Accessibility Survey

City of Downey Marbel Avenue - 5th Street to End

Disability Access Consultants

Sidewalks , Surface : Cross Slope

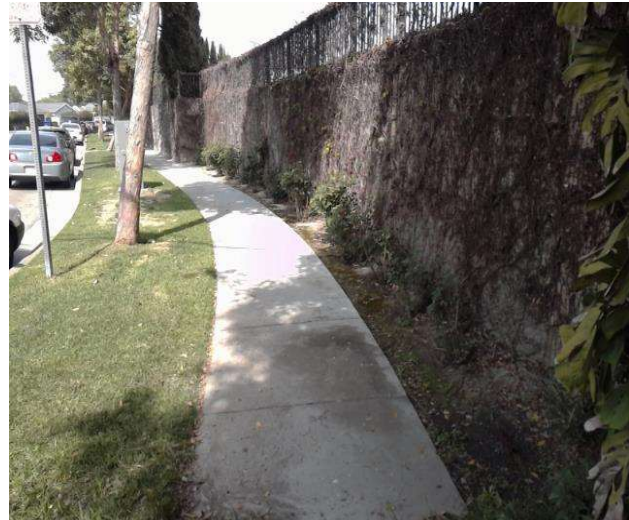
Sidewalk cross slope is not compliant.

On-Site Finding 3.60 percent for 100.00 feet

Repave the sidewalk surface with the recommended cross slope.

Recommendation Up to 2.08 percent

Sidewalks , Hazards & Gratings : Sidewalk Width at Obstruction

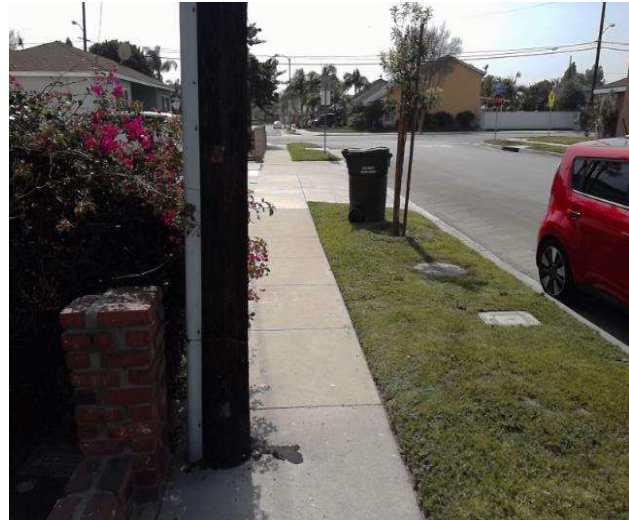
Sidewalk width at the obstruction is not compliant.

On-Site Finding 32.00 inches

Sidewalk width at the obstruction shall have the recommended value.

Recommendation At least 48.00 inches

Sidewalks , Change in Level : Change in Level Non Beveled

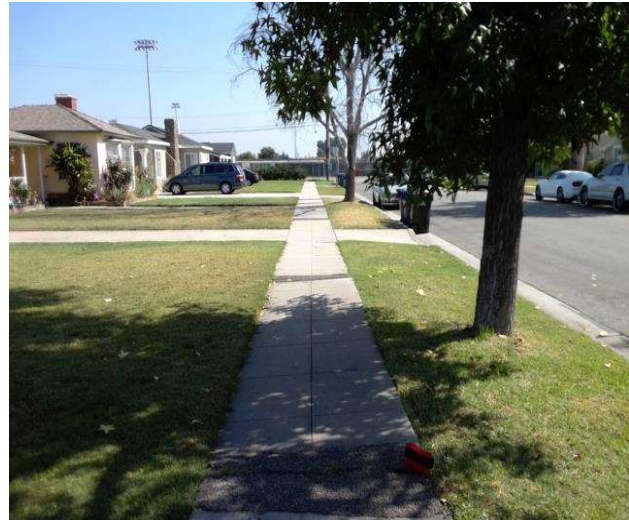
There is a change in elevation greater than recommended value.

On-Site Finding 2.00 inches

Ensure that the change in elevation is within the recommended value.

Sidewalks , Change in Level : Change in Level Non Beveled

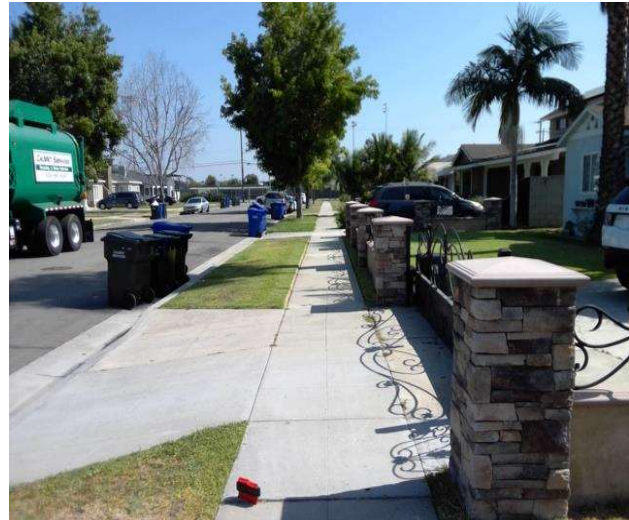
There is a change in elevation greater than recommended value.

On-Site Finding 0.50 inches

Ensure that the change in elevation is within the recommended value.

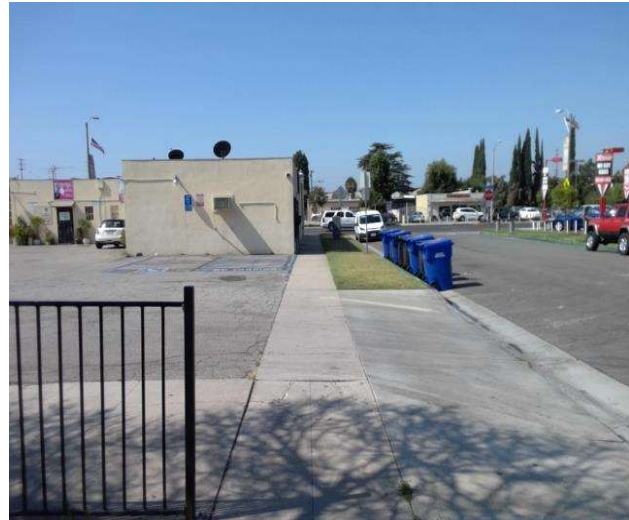
There are no detectable warnings where the pedestrian route crosses vehicular traffic.

On-Site Finding Not Found

Provide detectable warnings.

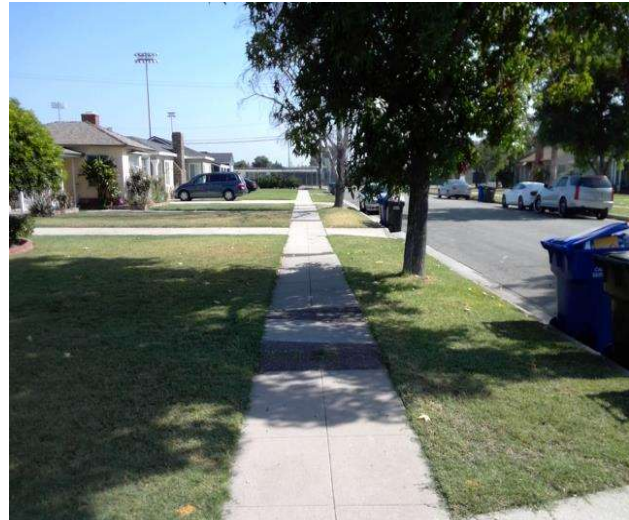
Sidewalk does not have enough width.

On-Site Finding 47.00 inches for 45.00 feet

Widen the sidewalk to the recommended value.

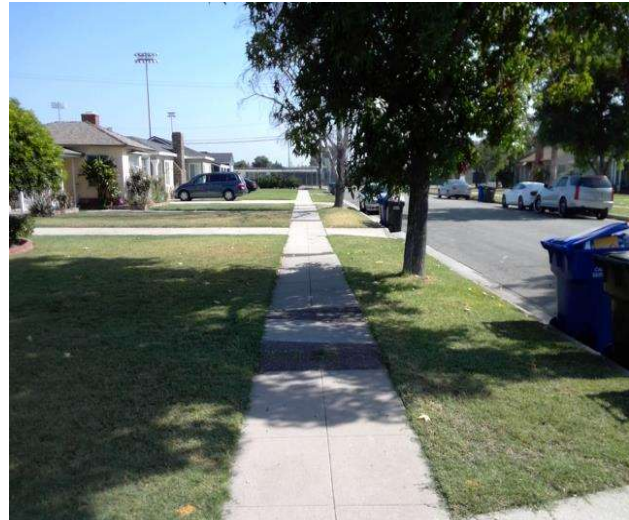
Sidewalk cross slope is not compliant.

On-Site Finding 6.60 percent for 45.00 feet

Repave the sidewalk surface with the recommended cross slope.

Sidewalks , Change in Level : Change in Level Non Beveled

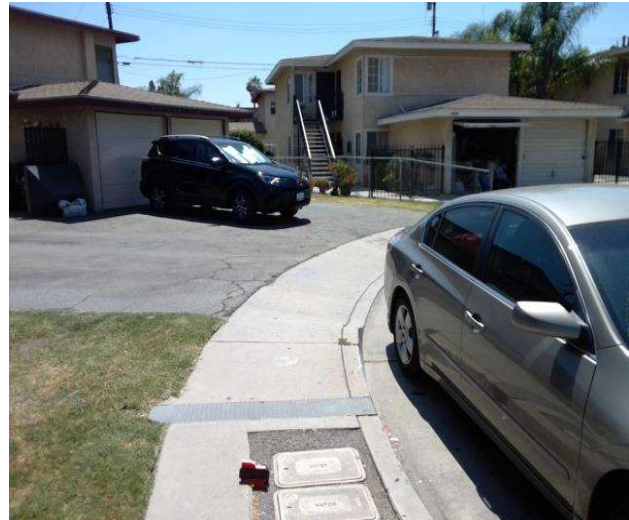
There is a change in elevation greater than recommended value.

On-Site Finding 1.00 inches

Ensure that the change in elevation is within the recommended value.

Sidewalks , Change in Level : Change in Level Non Beveled

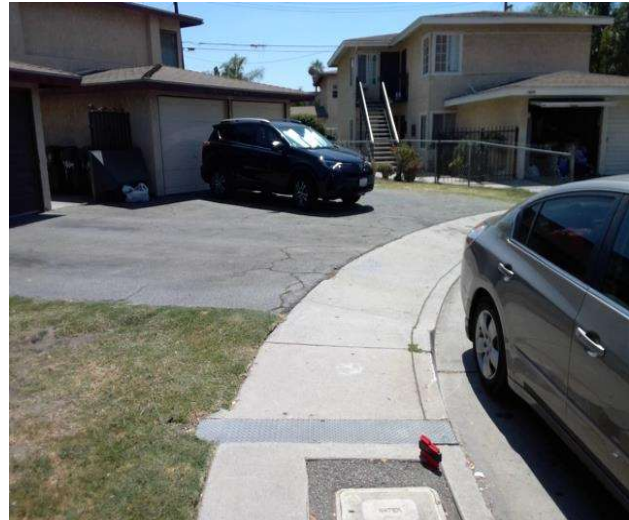
There is a change in elevation greater than recommended value.

On-Site Finding 0.50 inches

Ensure that the change in elevation is within the recommended value.

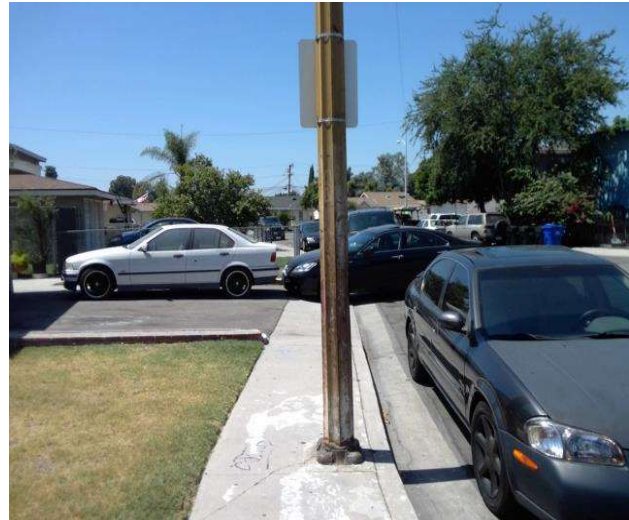
Sidewalk width at the obstruction is not compliant.

On-Site Finding 31.50 inches

Sidewalk width at the obstruction shall have the recommended value.

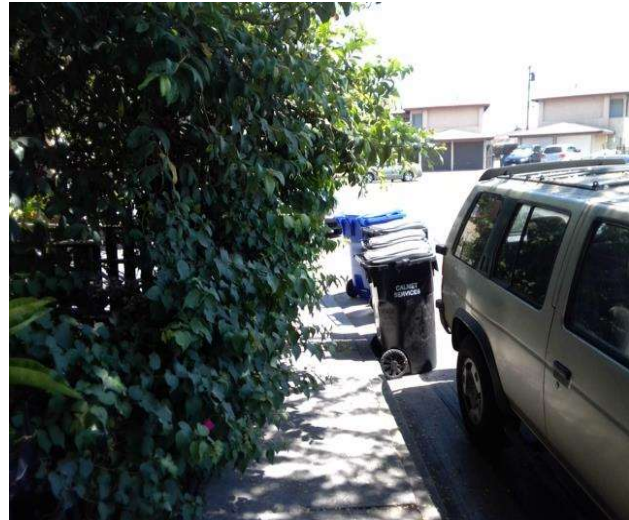
Sidewalk width at the obstruction is not compliant.

On-Site Finding 0.00 inches

Sidewalk width at the obstruction shall have the recommended value.

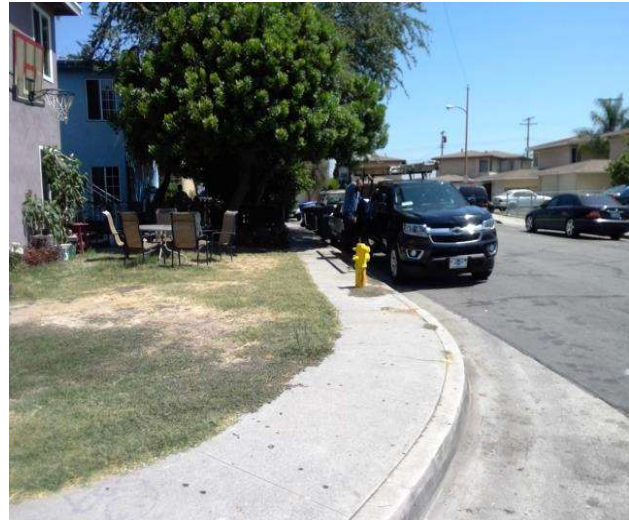
Sidewalk cross slope is not compliant.

On-Site Finding 4.40 percent for 25.00 feet

Repave the sidewalk surface with the recommended cross slope.

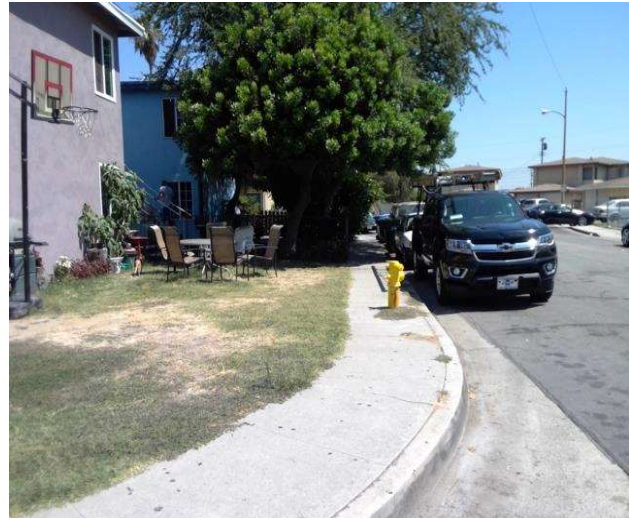
There is no 60X60 turn area at every 200 feet.

On-Site Finding Not Found

Provide a 60X60 turn every 200 feet on the sidewalk.

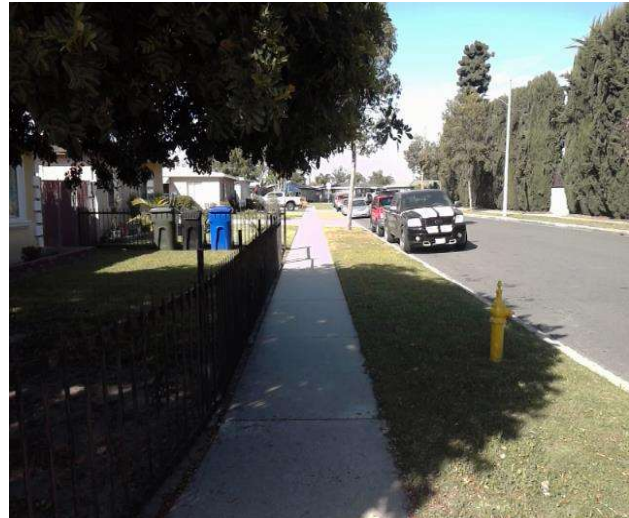
There is no 60X60 turn area at every 200 feet.

On-Site Finding Not Found

Provide a 60X60 turn every 200 feet on the sidewalk.
